Morgan Sindall

GCH-WID-XX-EL-RP-X-0001

MORGAN SINDALL		S4-Construction/Info Exchange
	A	Information Exchange – No Comments
	B	Information Exchange – With Comments. Please revise and resubmit with comments incorporated
	AC	For Construction – No Comments
X	BC	For Construction – With Comments. Please revise and resubmit with comments incorporated
	C	Rejected - Please revise and resubmit with comments incorporated
Reviewed by (Sign and Date):		
PB 14/06/2022

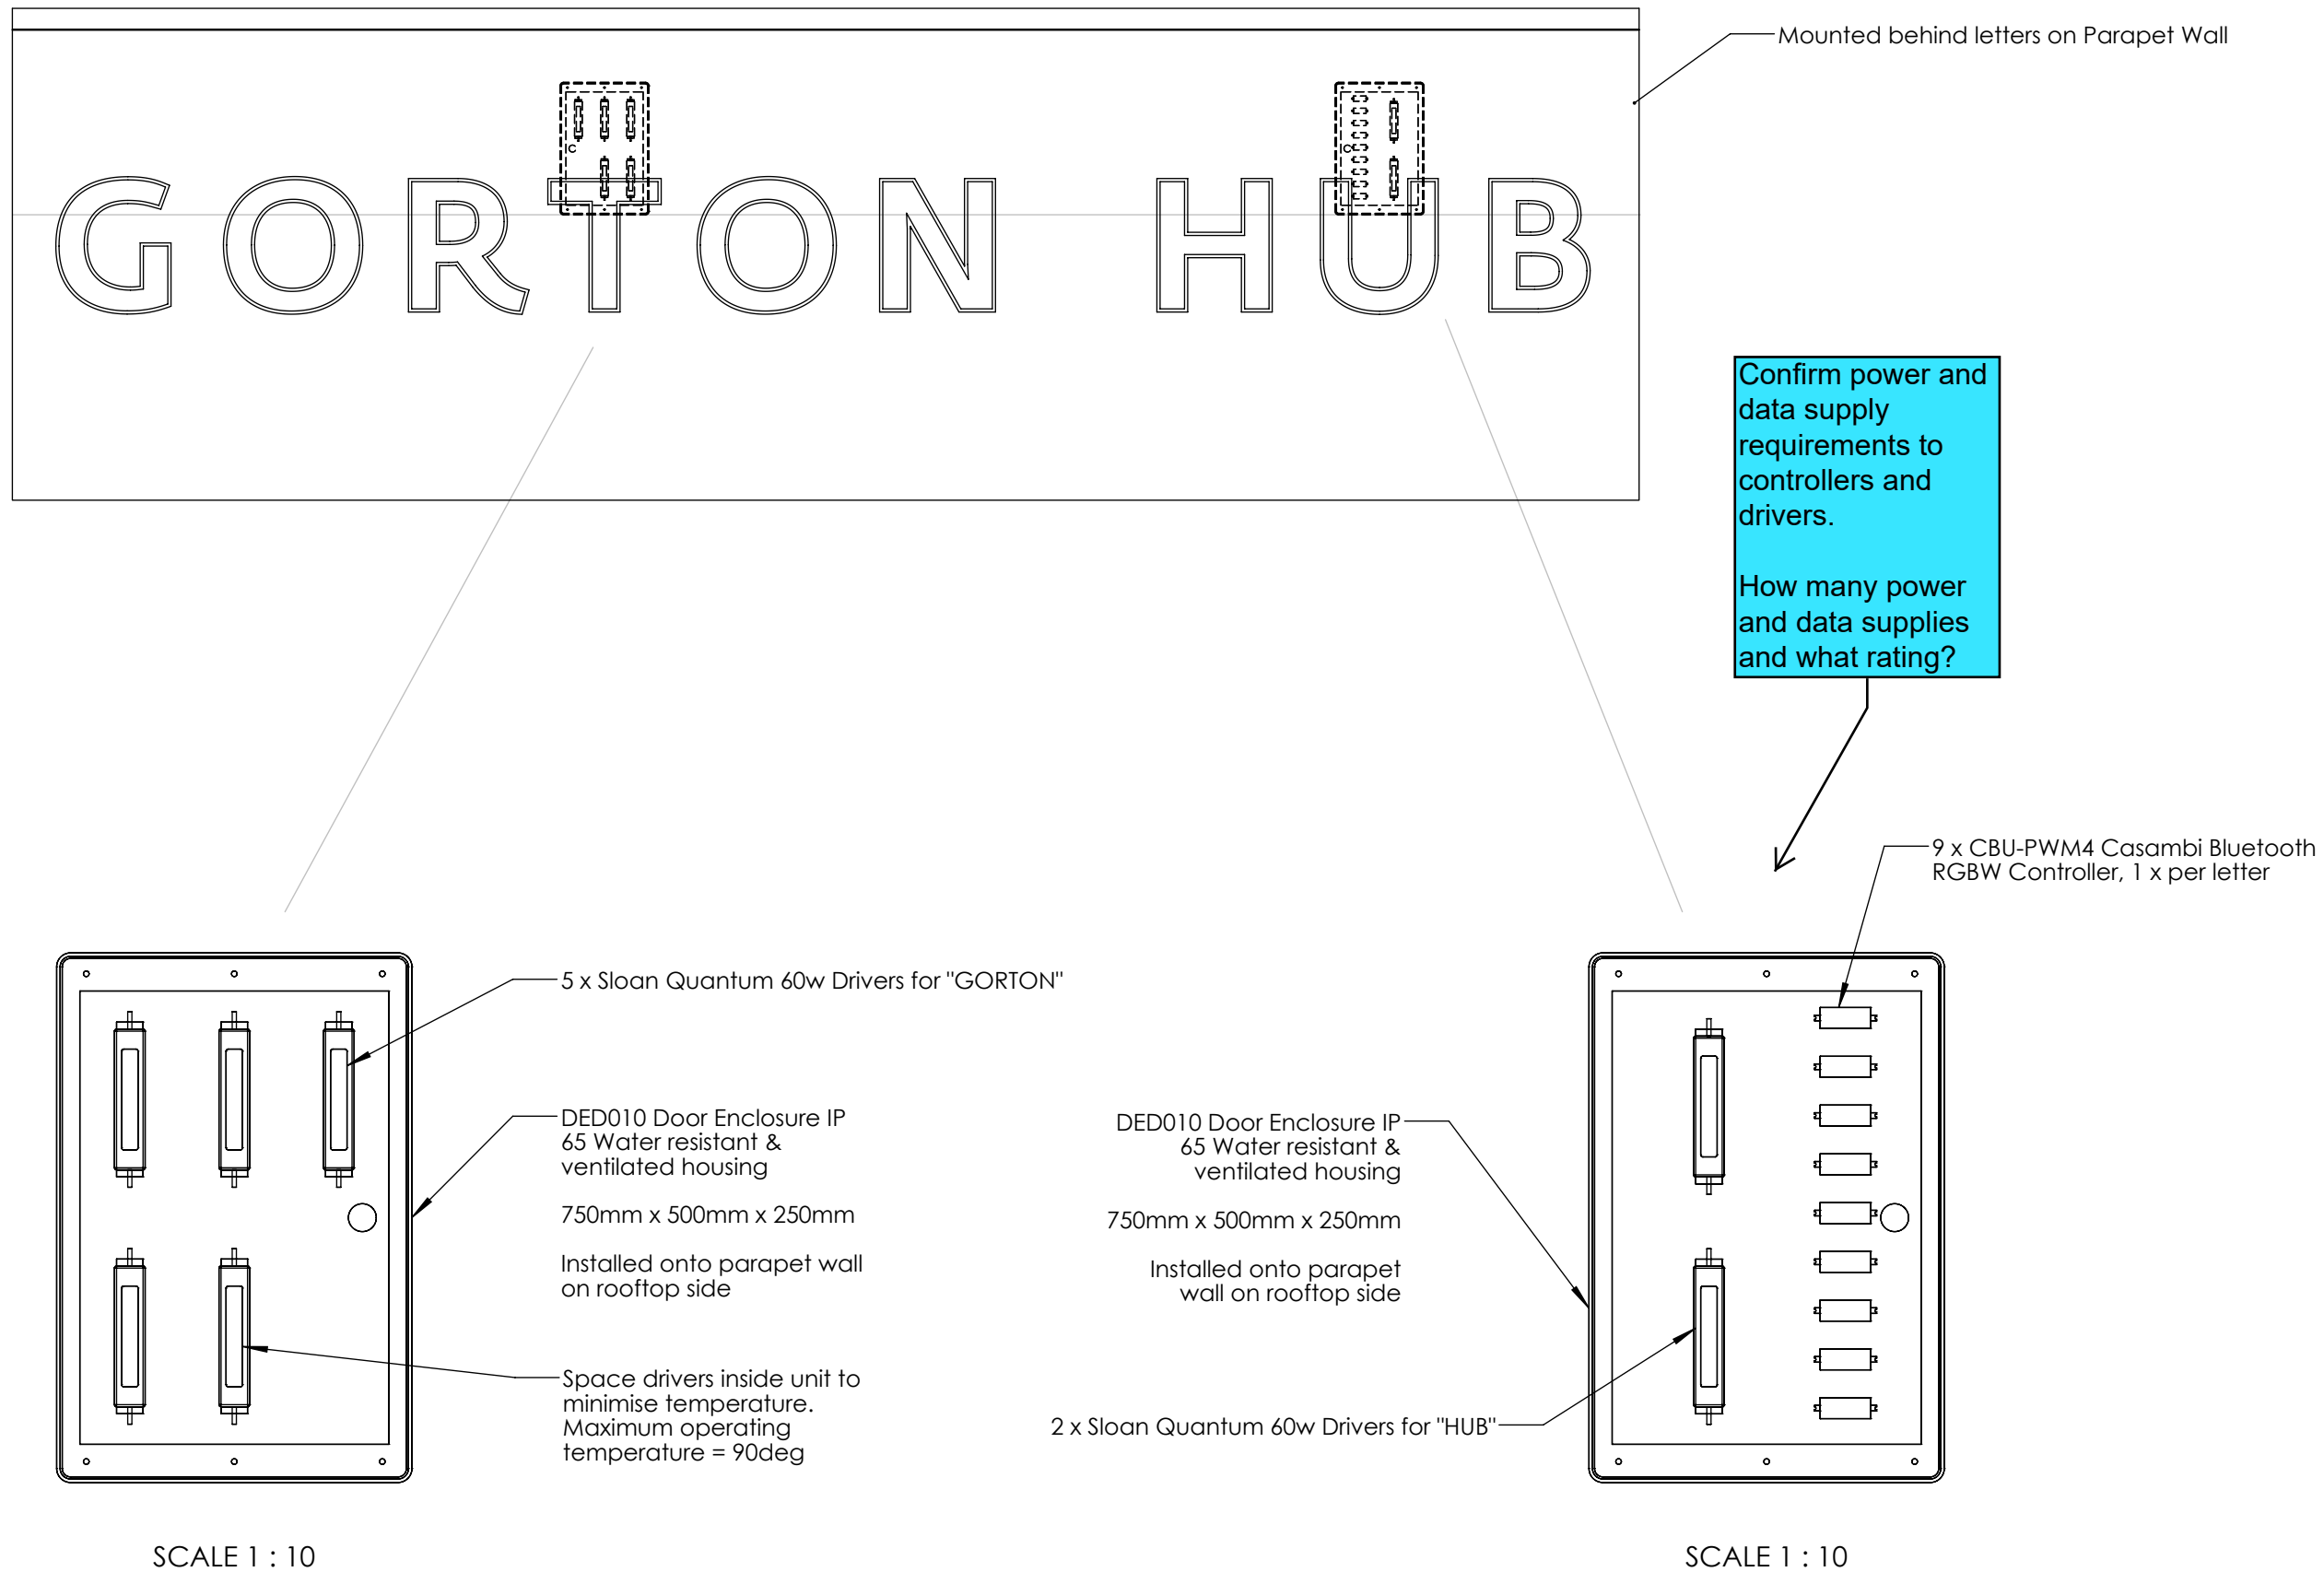
Comments as drawing 3

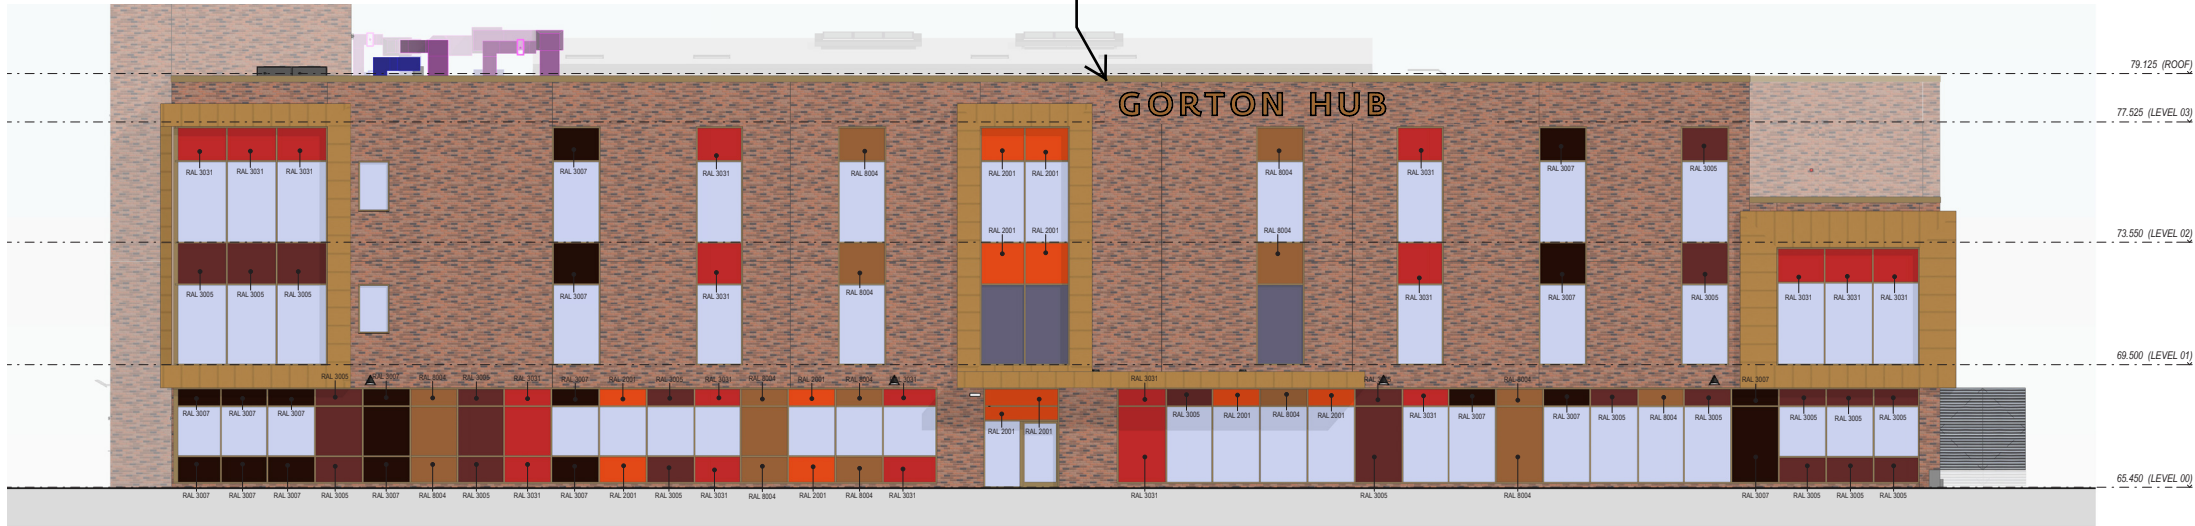
Provide setting out dimensions for signage on elevations
